REMARKS

In response to the Office Action dated January 12, 2000, Applicants respectfully request reconsideration. To further the prosecution of this application, amendments have been made in the claims, and the claims as presented are believed to be in allowable condition.

Docket No. B0932/7088
Dated: May 12, 2000
x05/12/00x

Fig 29

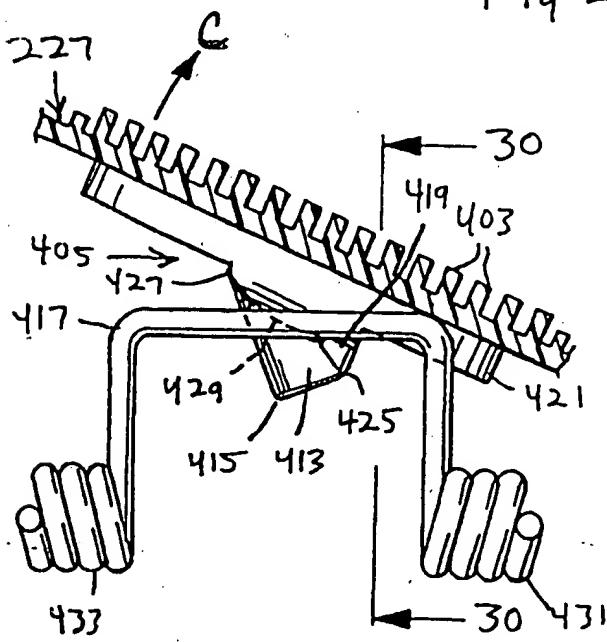
In ¶6, the Office Action objects to the drawings as not complying with the specification. In response, the reference character at page 21, line 28 has been corrected to --103-- as suggested by the Examiner, and a proposed revised Fig. 29 is included with reference character C added for the arrow.
